# Intersection Design and Traffic Assessment

**Relocation of Windsor Road / Mt Carmel Road Intersection, Box Hill**

**X11295.R**

Prepared for Mogul Stud/ Jundu

Figure 3-4: Conceptual Intersection Layout Supported by RMS

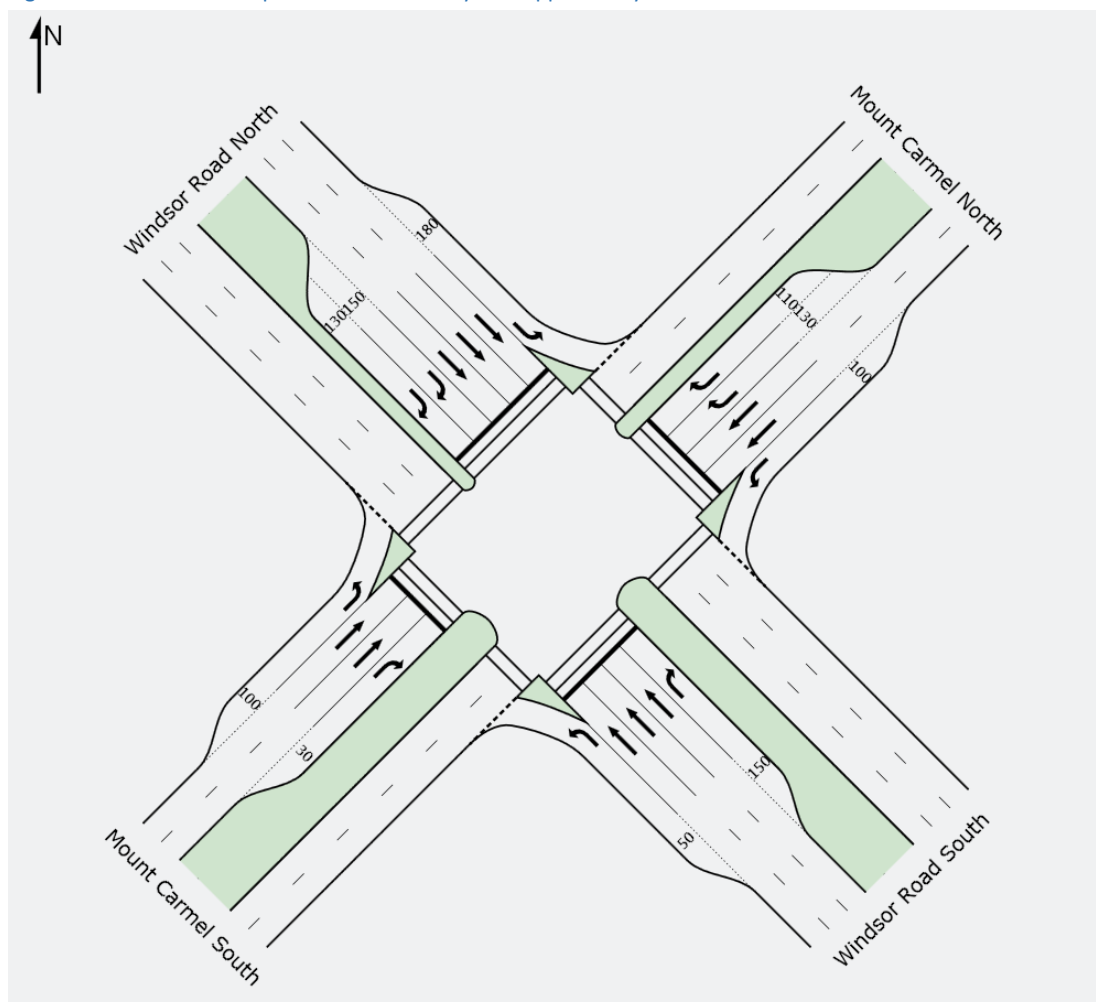
No.	RMS' comments	Response
1	Median widths of 1.2m in Windsor Road are too narrow, the desirable width is 2.4m. If staged crossings in Windsor Road are required 3.6m. Also the median width in the side road on the northern side should be 2.4, and the width of the median on the side road on the southern side should be 2.4m, 2.0m from the nose. These widths are to cater for signal posts/ push buttons and refuges for pedestrians	Median widths amended accordingly
2	There is no provision for bus jump starts or bus stops on the departure side of the intersection in Windsor Road. It should be noted that both the Garfield Road/ Windsor Road and the Boundary Road/ Windsor Road have bus jump starts and bus stops	Bus jumps starts and bus stops have been provided in design
3	No provision for on road cyclists to travel through the intersection. The preferred option is to have a 4.5m wide left turn lane, with the existing shoulder running into this 4.5m lane and an area of 1.5m in width between the traffic island and the bus jump start	Provision for on road cyclists incorporated into design

4	The two islands on the northern side are to be of sufficient size to cater for all traffic signal furniture i.e. mast arms, pram ramps etc. This especially applies to the island on the north eastern corner. There should also be sufficient room to cater for the scenario where the zebra crossing across the left turn lanes are signalised to cater for cyclists. Where a proposed shared path connects to the signals the crossings across the left run lanes have to be signalised	The two islands are of sufficient size to cater for the signal furniture, including the scenarios mentioned by RMS
5	Lane widths in Windsor Road vary from 3.25m to 3.5m. Lane widths of 3.2m for both through lanes and right turn lanes are acceptable	All lanes have been redesigned to 3.2m
6	Ensure that all merge and diverge tapers are appropriate for the design speed. Which I assume is 90kph as the posted speed is 80kph	Tapers are appropriate for the design speed

7	Will the proposed Mt Carmel Road become an arterial road and handed to the RMS in the future?	Mt Carmel Road is proposed to operate as a Sub-Arterial Road from Windsor Road to the Killarney Chain of Ponds and as a collector road further north

- 1) Median widths of 1.2m in Windsor Road are too narrow, the desirable width is to be 2.4m. Or if staged crossings in Windsor Road are required 3.6m. Also the median width in the side road on the northern side should be 2.4m and the width of the median on the side road on the southern side should be 2.4m 2.0m from the nose. These widths are to cater for signal posts/push buttons and refuges for pedestrians. Network Operations should be consulted about what would be preferred.

- 2) There is no provision for bus jump starts or bus stops on the departure side of the intersection in Windsor Road. It should be noted that both the Garfield Road/Windsor Road and the Boundary Road/Windsor Road have bus jump starts and bus stops.

- 3) No provision for on road cyclists to travel through the intersection. The preferred option is to have a 4.5m wide left turn lane, with the existing shoulder running into this 4.5m lane and a area of 1.5m in width between the traffic island and the bus jump start.

- 4) The two islands on the northern side are to be of sufficient size to cater for all signal furniture i.e. mast arms, pram ramps etc. This especially applies to the island on the north eastern corner. There should also be sufficient room to cater for the scenario where the zebra crossing across the left turn lanes are signalised to cater for cyclists. Where a proposed shared path connects to the signals the crossings across the left turn lanes have to be signalised.

- 5) Lane widths in Windsor Road vary from 3.25m to 3.5m. Lane widths of 3.2m for both through lanes and right turn lanes are acceptable.
- 6) Ensure that all merge and diverge tapers are appropriate for the design speed. Which I assume is 90kph as the posted speed is 80kph.

- 8) Will the proposed Mt Carmel Road become an arterial road and be handed to the RMS in future? As the lane widths are only 3.0m and are considered too narrow.

Figure 6-1: Windsor Rd / Mt Carmel Rd Final Intersection Layout

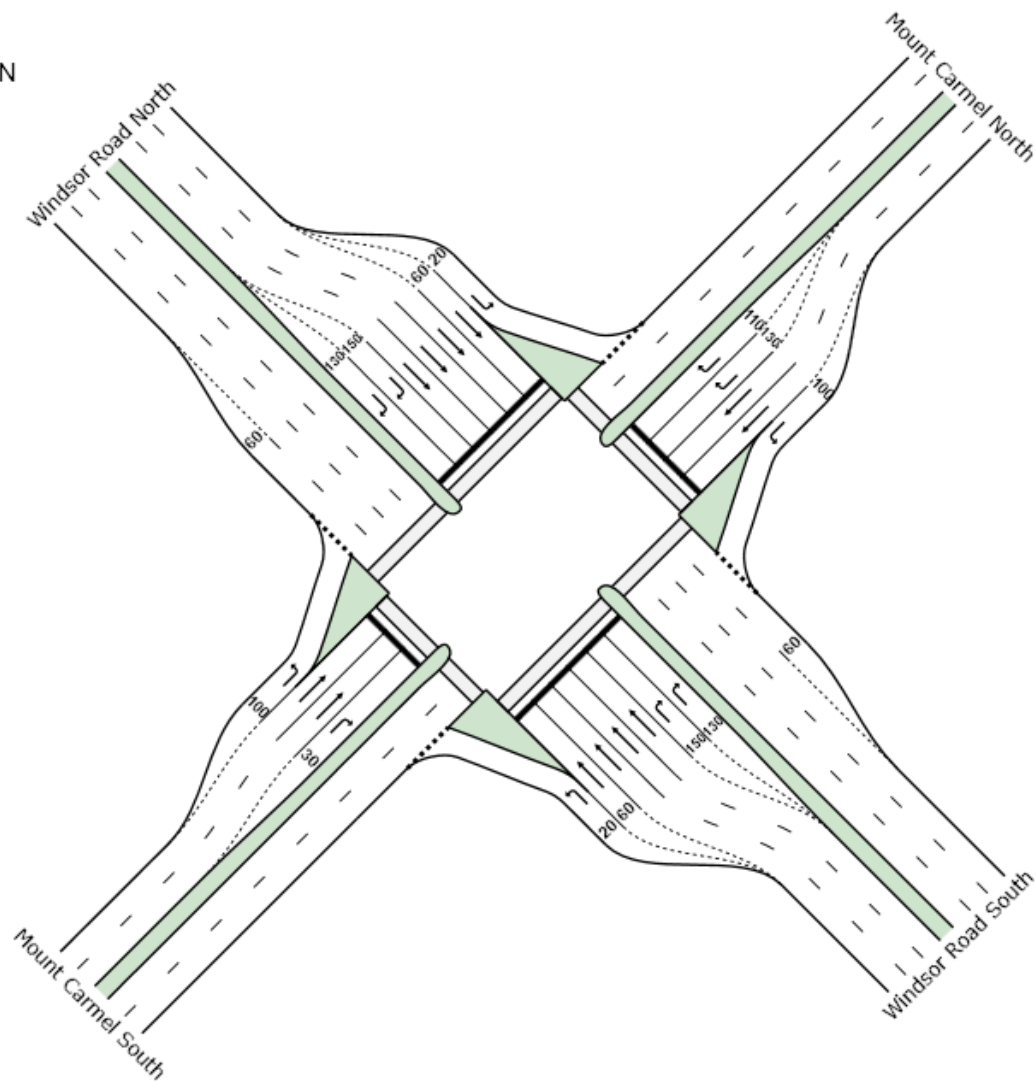
The Mt Carmel Road / Windsor Road intersection has been remodelled to include the comments provided by the RMS (as detailed in Table 4.2) and all additional constraints (as listed in Section 5) including a total of two right turn lanes for motorists turning right from the southern leg of Windsor Road. No changes have been made to the traffic volumes adopted in the previous analysis. The latest proposed layout, phasing arrangement during each peak period and the results of the Sidra analysis are presented in the following figures and Table 6-3.
